SPRINGS LOFTS

RFI#: 37 Date: 1/23/2012 Job: EB-02 Keller Springs Lofts Phone: 877-777-5115

Date Required: 1/25/2012 Request: On sheet P-3.0C the main sanitary trunk line is shown running in the center of the corridors. It is 6" running north along the east side of the garage. It joins another 6" running east along the north side of the garage. So we have a 6" joining with another 6" but there is no designation as to the size of the line after that until it meets the 10" that leaves the building. Sheet P-3.0E gives no designation to the size of this line either. I feel this may be an oversight and the intention would be to have the large to an 8" after the (2) 6" lines merge. Please advice and respond as we are going to be installing these lines in the next two days.

Answered by: Heath Parnell Jordan & Skala Engineers, Inc.

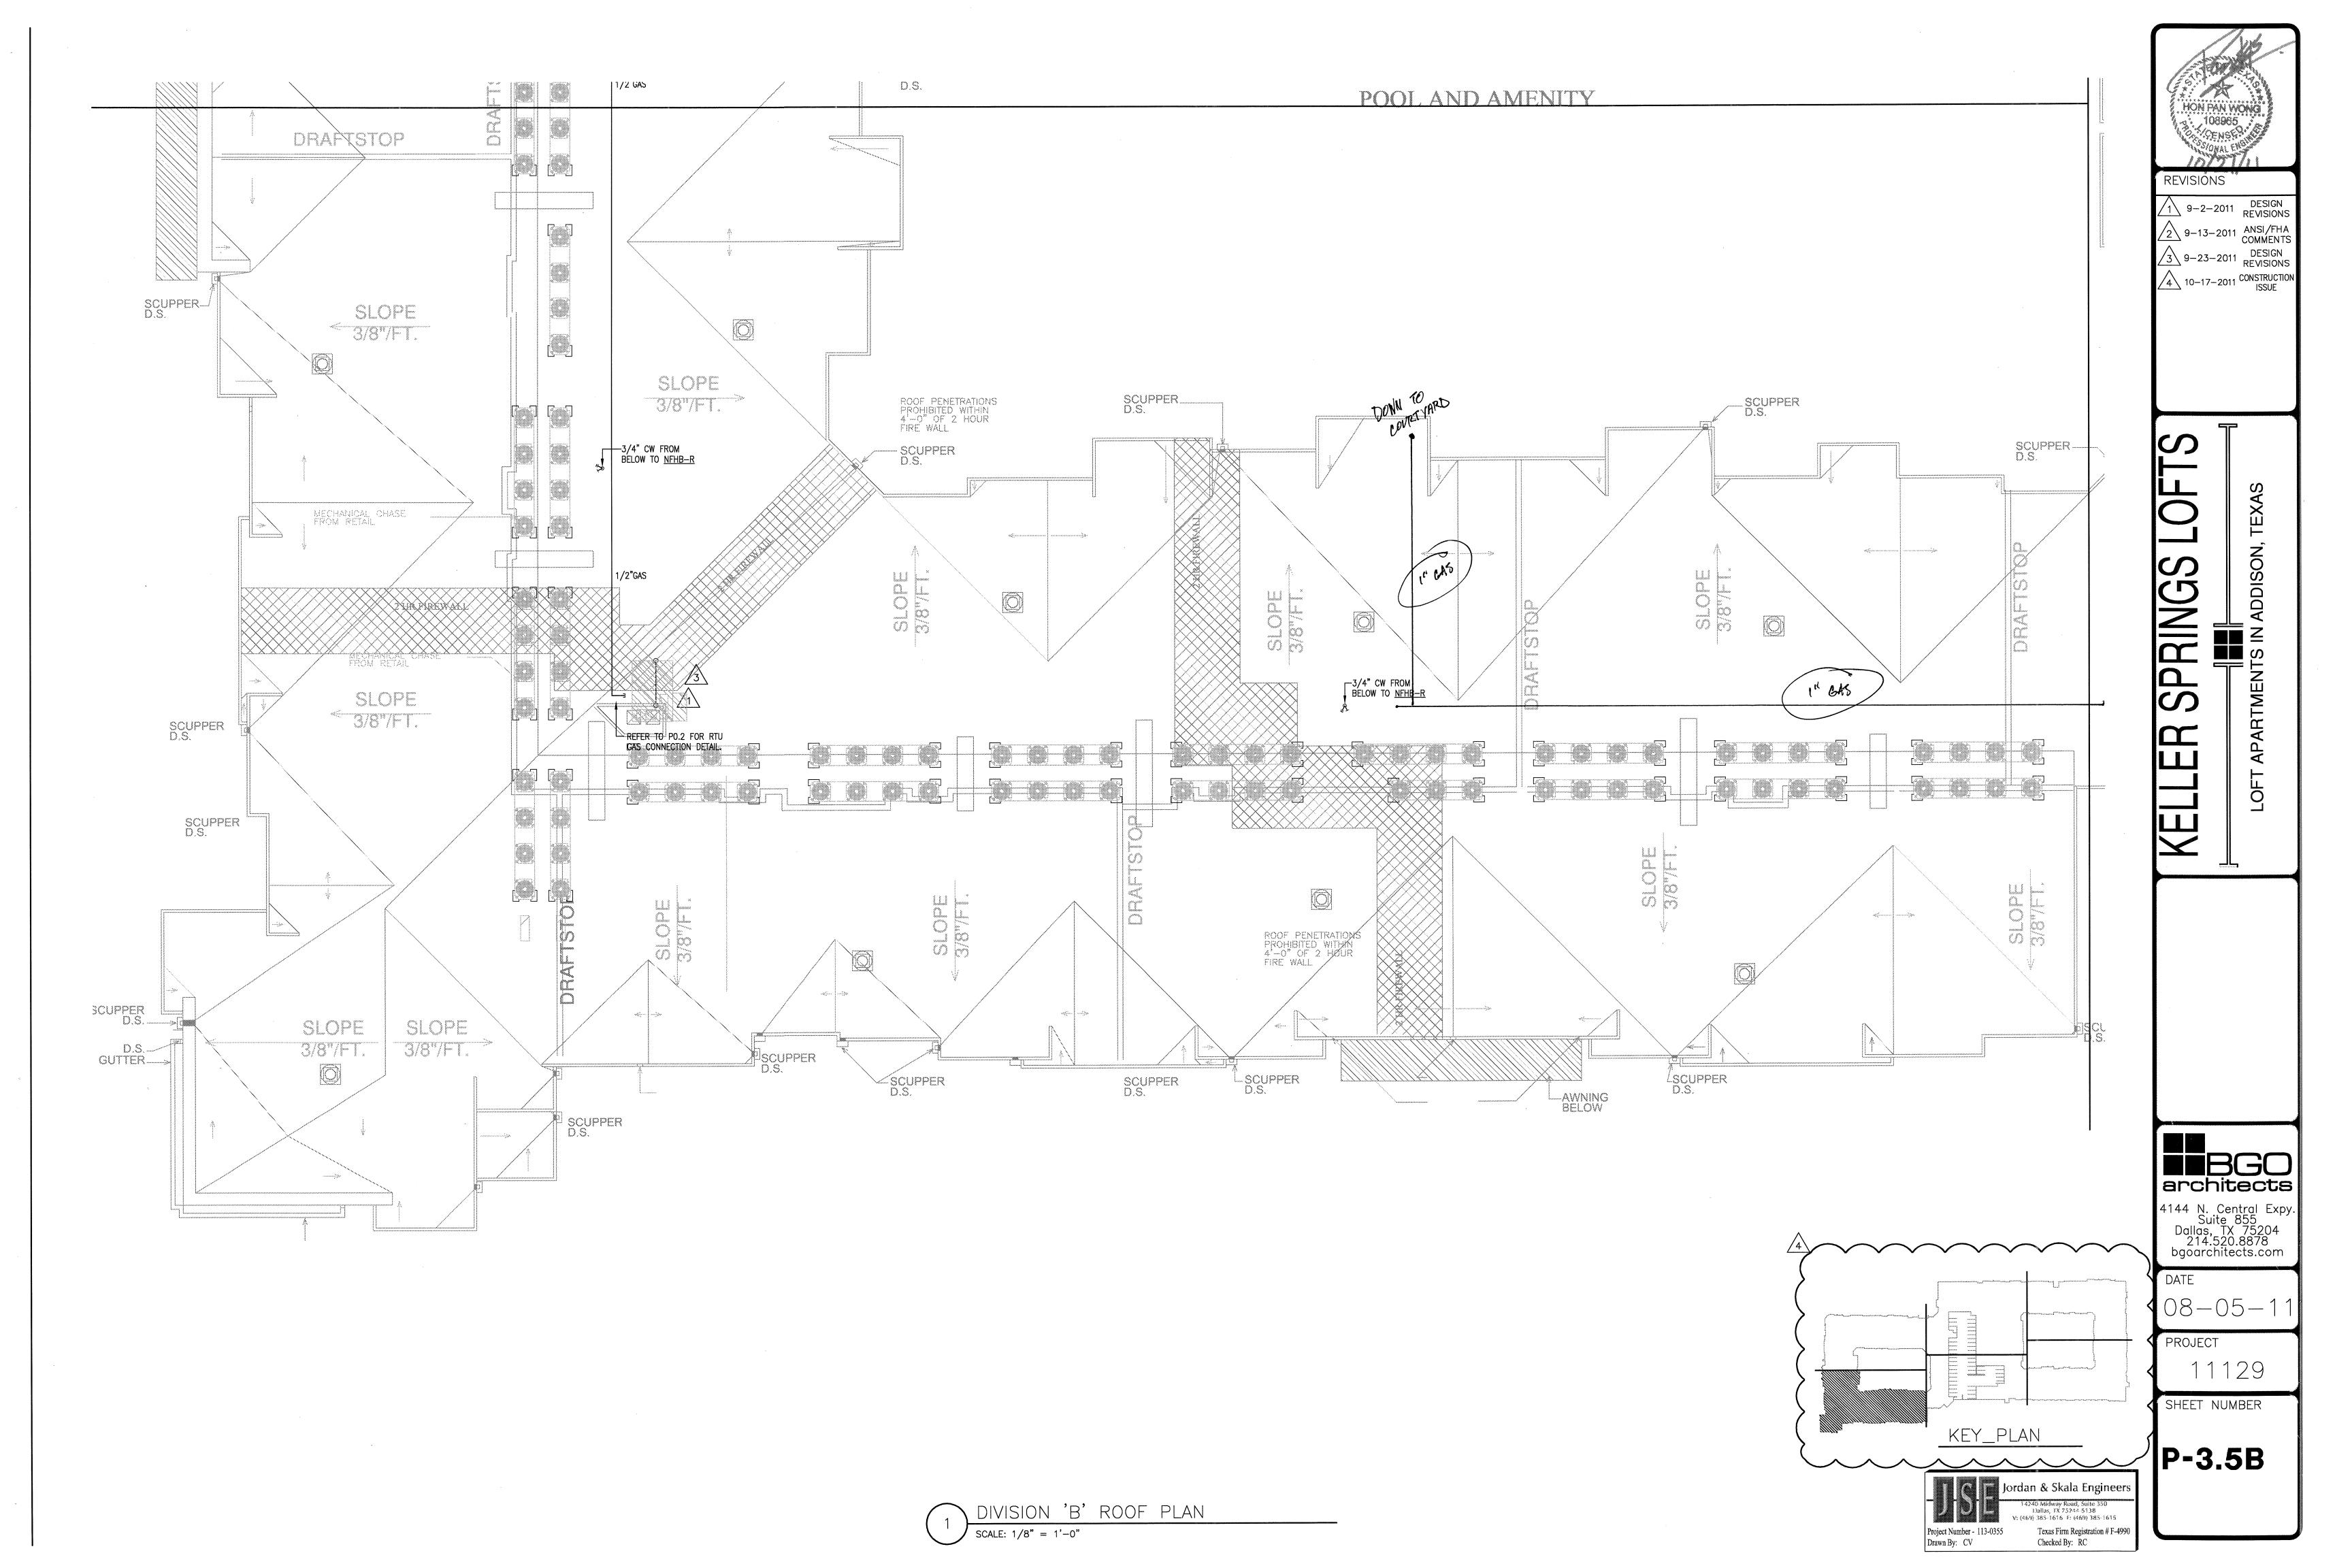
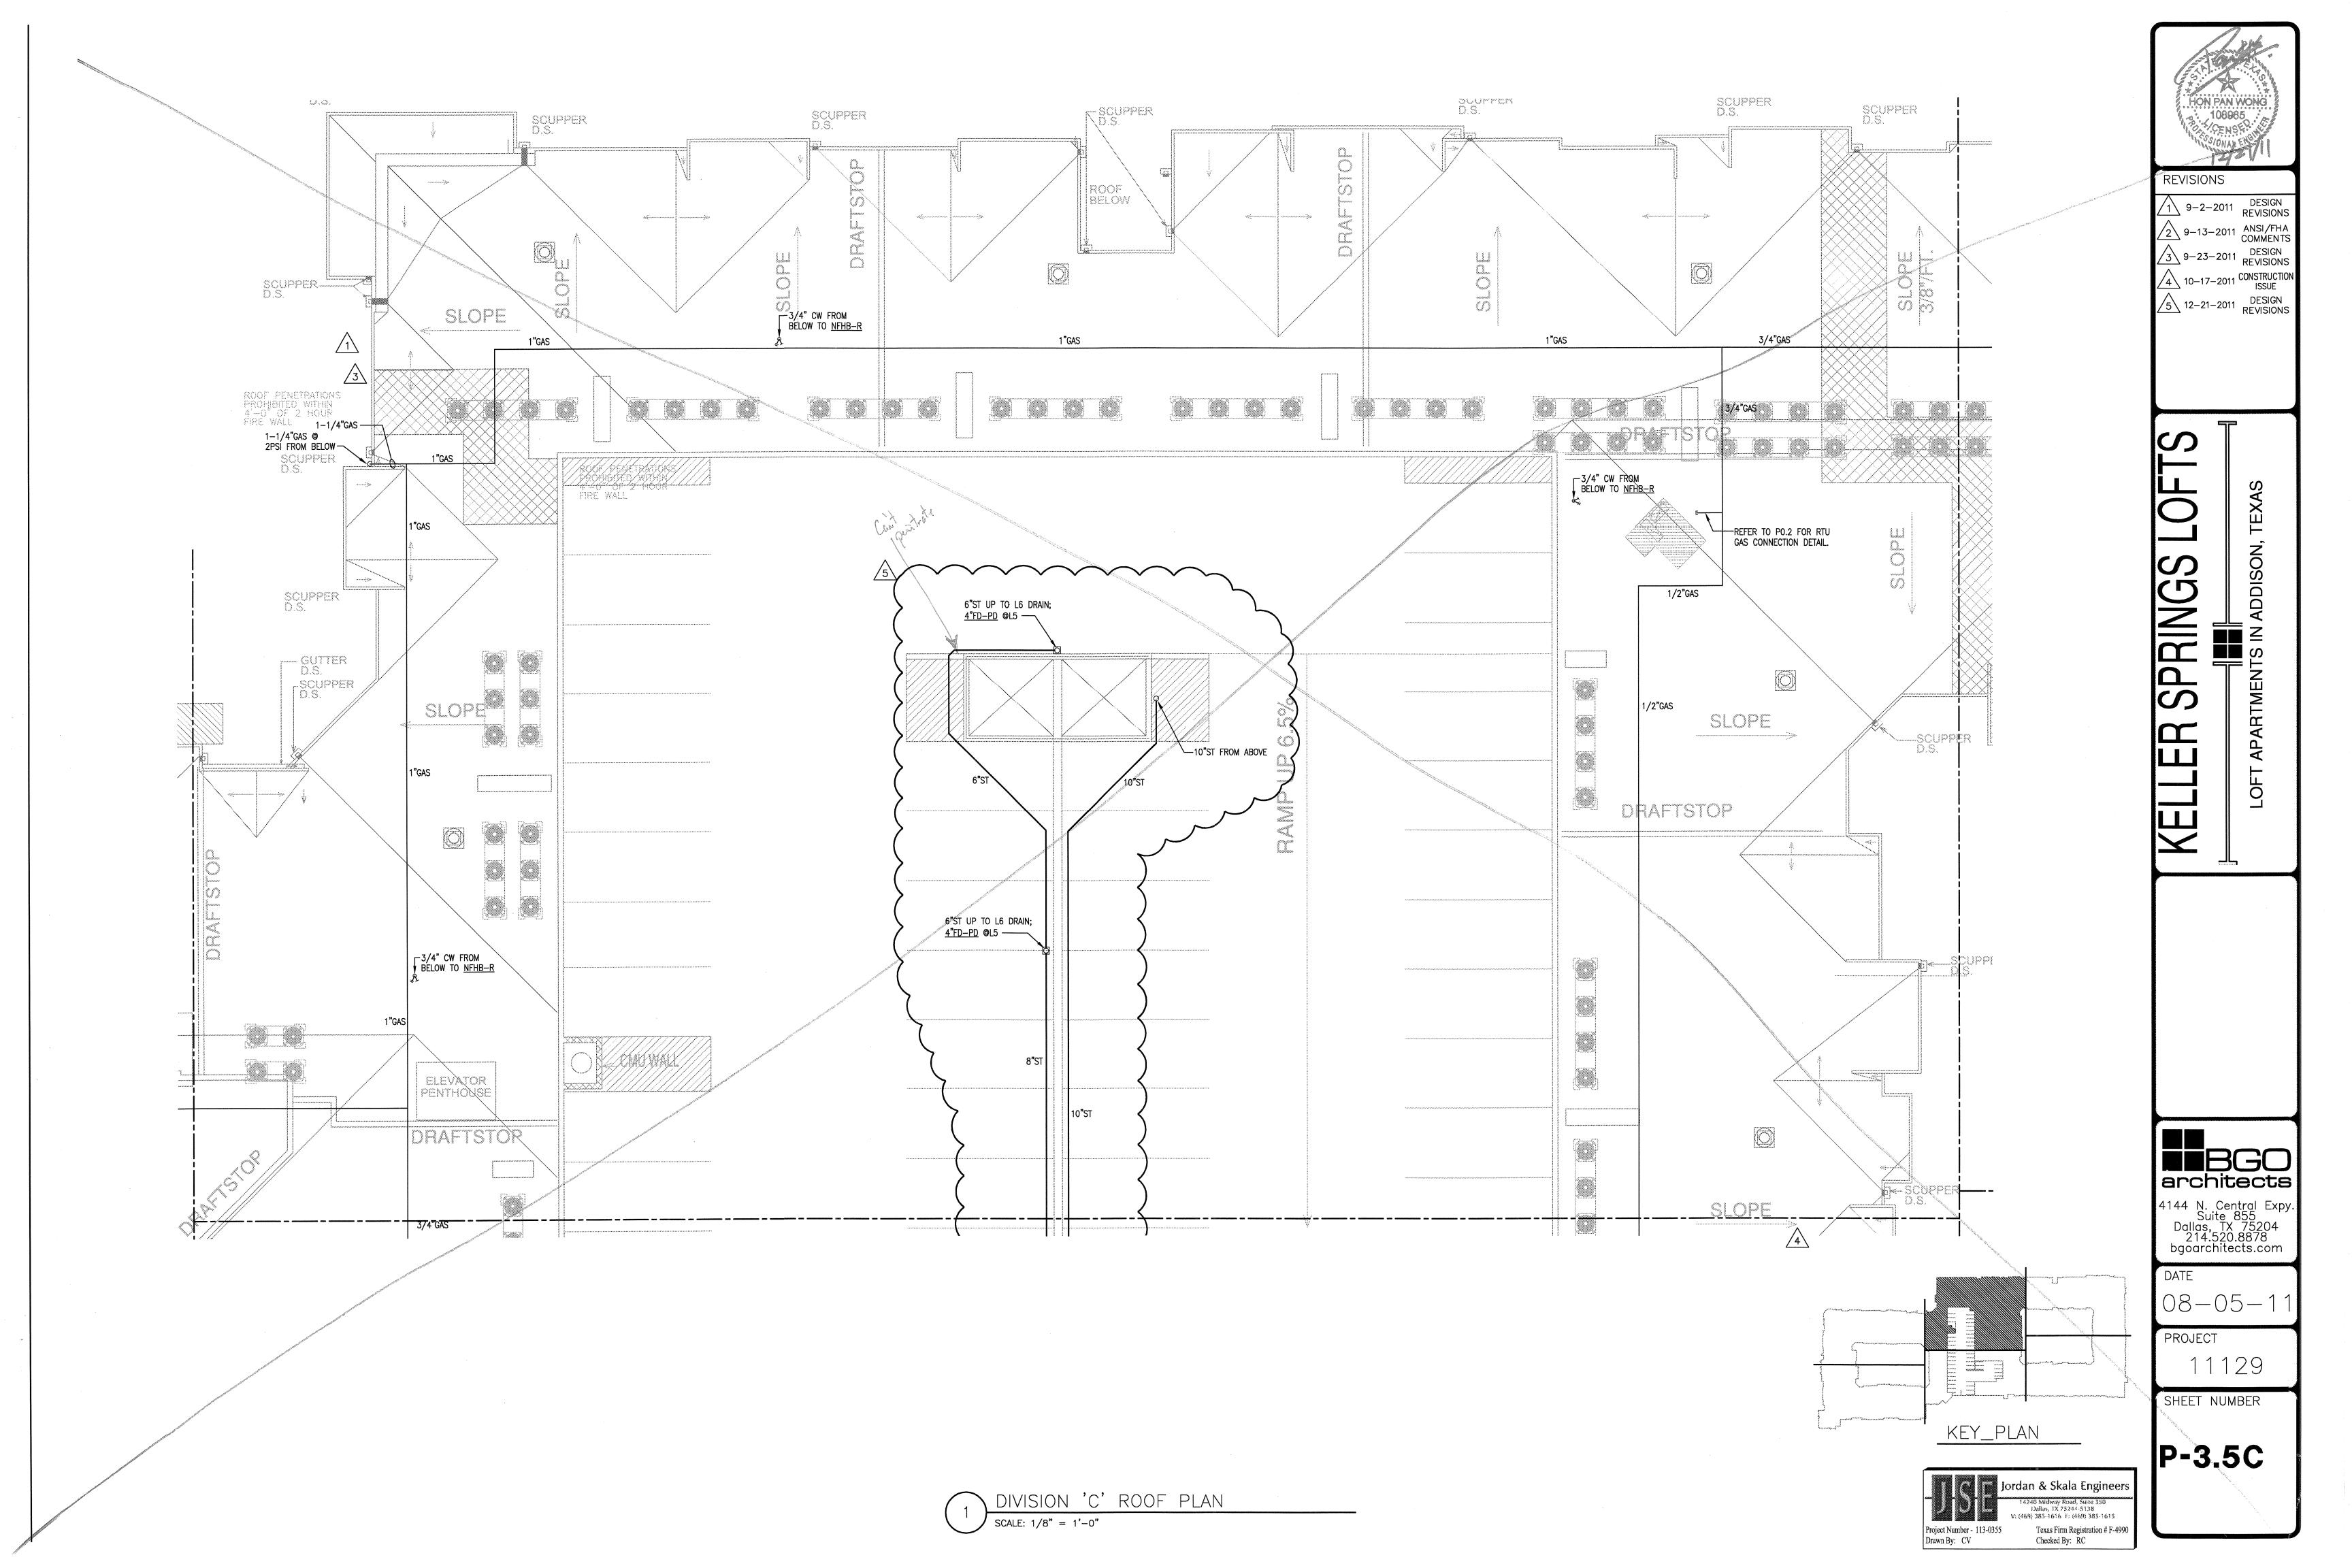
Date Required: 10/26/2012 During an on-site meeting with Walter Kilroy and Ryan Faulds of BGO Architect it was determined that we would use a drain and overflow on top of the radius located on the northwest corner of the west building. The plans showed (2) scuppers with downspouts which would not work because of the exterior angle on the radius feature. It was decided that the drain line would be located inside the radius tower until it penetrated the side of the radius tower just about the stucco receiver and drain onto the main roof. We will properly slope the roof and build crickets for the water to enter the drain. Please size and detail the drain and drain lines Jordan & Skala deems appropriate for this task. Request:

it is recommended that 4" drains and drian lines be used for the tower. Roof drain shall be Jay R. Smith #1015 or equal and overflow drain shall be Jay R. Smith #1080 or equal. provide downspout nozzle Jay R Smith #1770 or equal at discharge point.
